Conditional Gateway Certificate Bylong Coal Project

Date certificate issued: 15 April 2014

**Report by the Mining & Petroleum Gateway Panel
to accompany a Conditional Gateway Certificate
for the Bylong Coal Project**

15 April 2014

Figure 4. Equine CIC within the Project Boundary area (after Hansen Bailey, 2014)

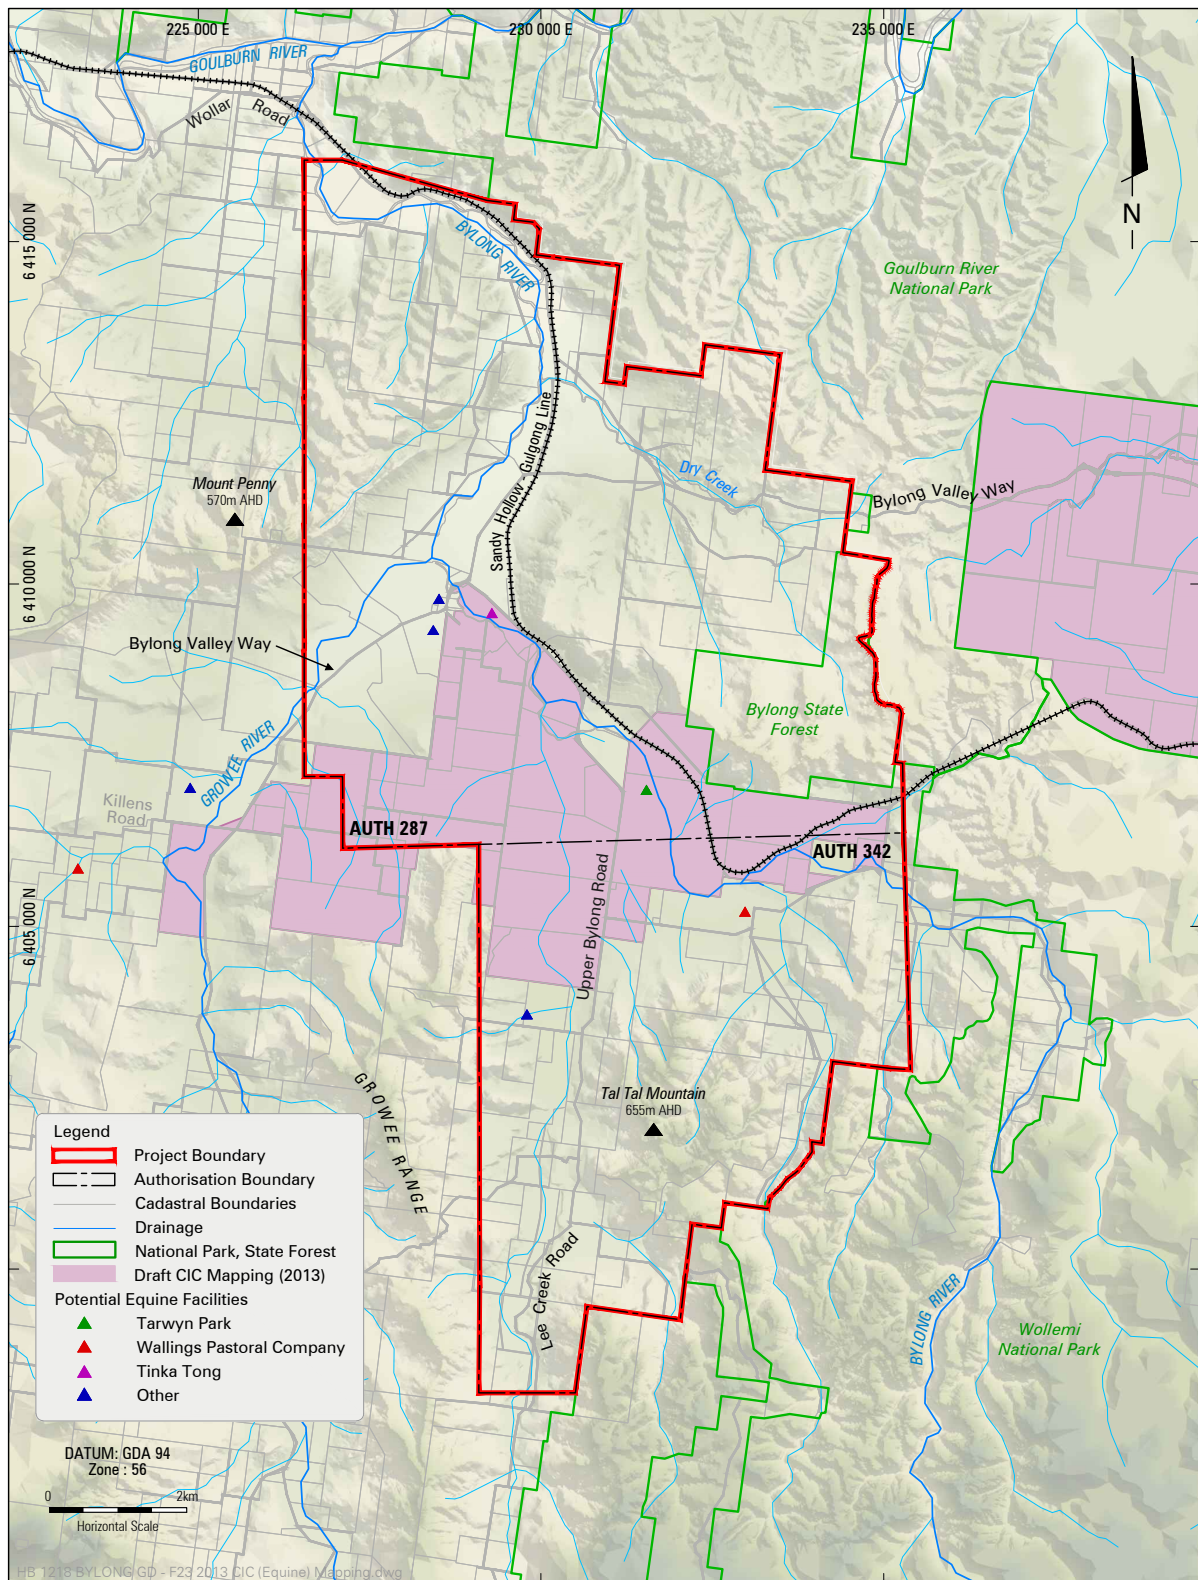
With regard to Equine CIC land, Hansen Bailey (2014) proposes that there are errors in both the DP&I (2012a) and Mining SEPP Critical Industry Cluster Land Map Sheet CIC_001 mapping. Hansen Bailey (2014) concludes that there is no Equine CIC land relevant to Project and therefore, no requirement for assessment of potential impacts.

If Applicants wished to contend the draft mapping of Equine CIC land, then they must have lodged a Site Verification Application to Planning & Infrastructure, prior to January 2014. The assessment of Site Verification Applications is not a function or responsibility of the Gateway Panel. Verification of Equine CIC land has never been part of the Gateway process.

Within the Project Boundary, the strategic regional land use plan (DP&I, 2012) indicated about 6,617 ha of Equine CIC land. In January 2014, the NSW Government verified Equine CIC lands in the Upper Hunter region and this revised mapping indicates 1,933 ha of Equine CIC land within the Project Boundary, as confirmed by Hansen Bailey (2014).

- The Applicant did not lodge a Verification Application to Planning & Infrastructure;
- The Interim Verification Protocol is now obsolete and can no longer be used; and,
- Verification of Equine CIC land was never a component of the Gateway process.

Figure 5. Verified BSAL (2,366 ha) within the Project Boundary area (after Hansen Bailey, 2014)

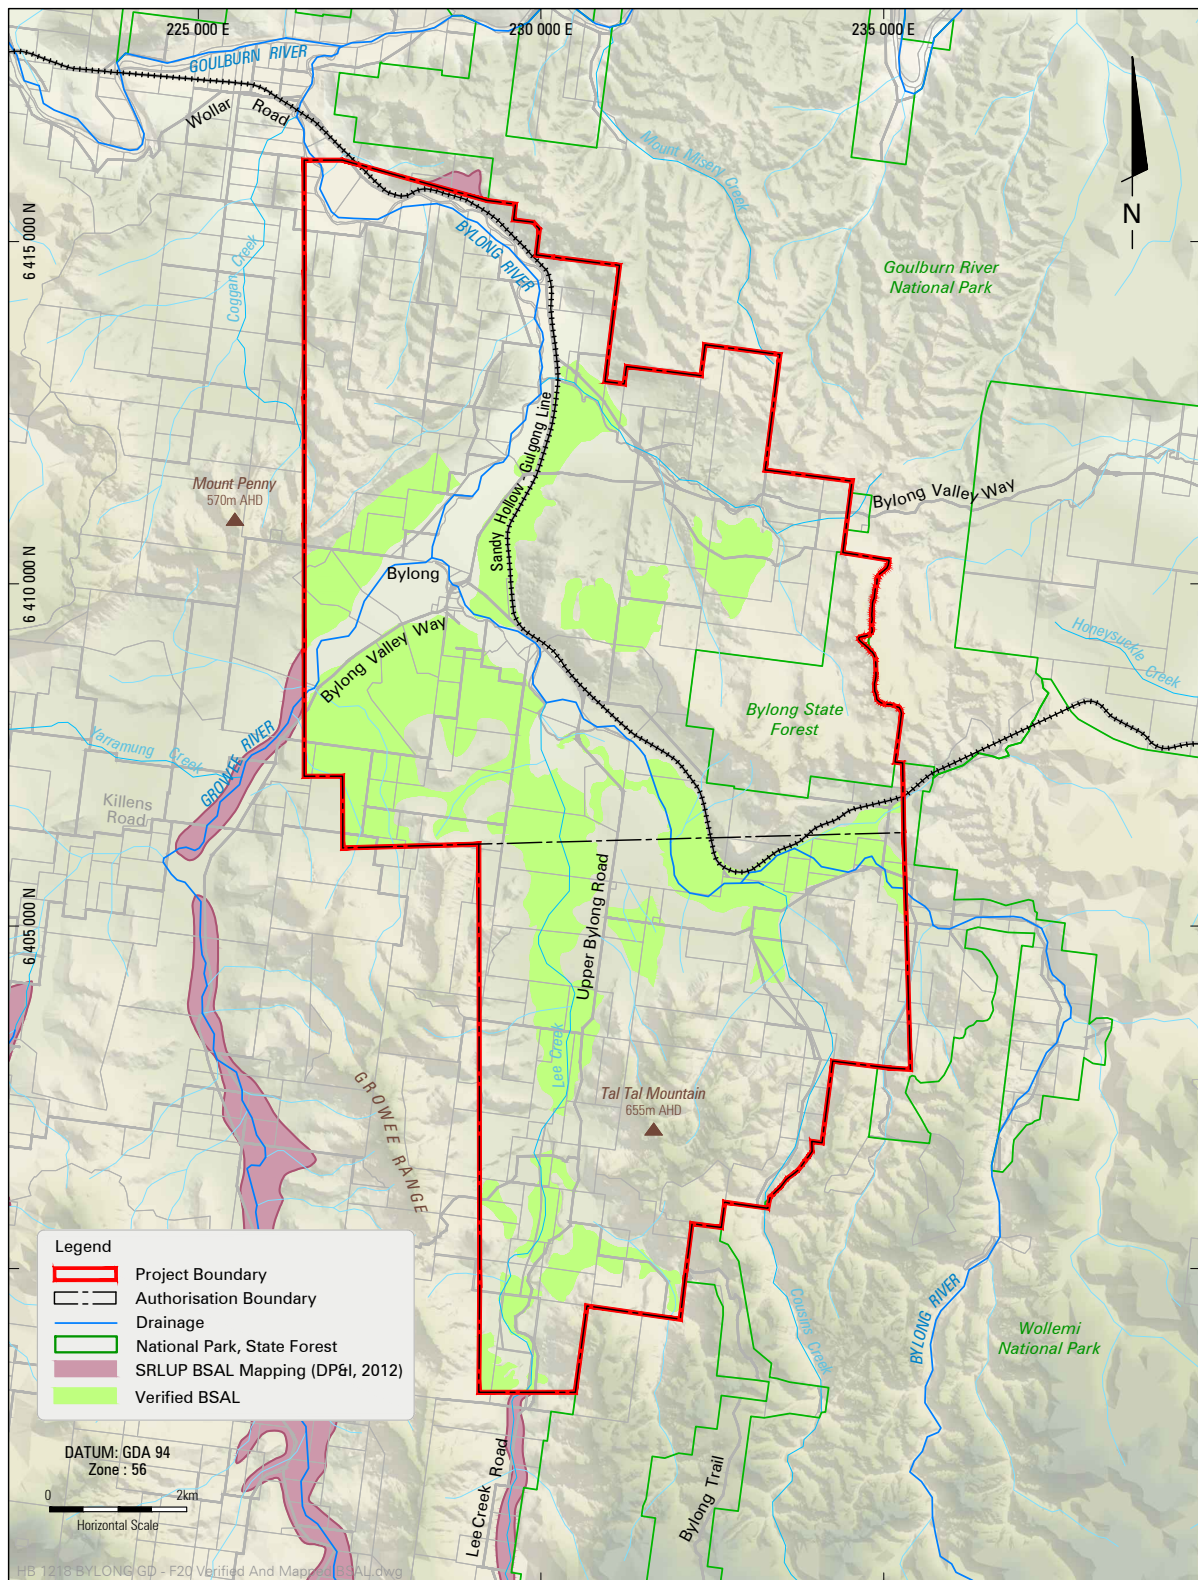
According to Hansen Bailey (2014) however, there is 2,366 ha of verified BSAL soils within the Project Boundary (Figure 5) and 367 ha of these will be impacted by the Project (Table 1). Inconsistently, SLR (2013a and 2013b) and Barnett (2013) discuss potential impacts to 401 ha of verified BSAL soils.

The Applicant verifies 2,366 ha of BSAL within the Project Boundary but provides insubstantial information of how verified BSAL within the Project Boundary but outside of planned disturbance areas is impacted or how potential BSAL outside of the Project Boundary is potentially, indirectly impacted by the Project.
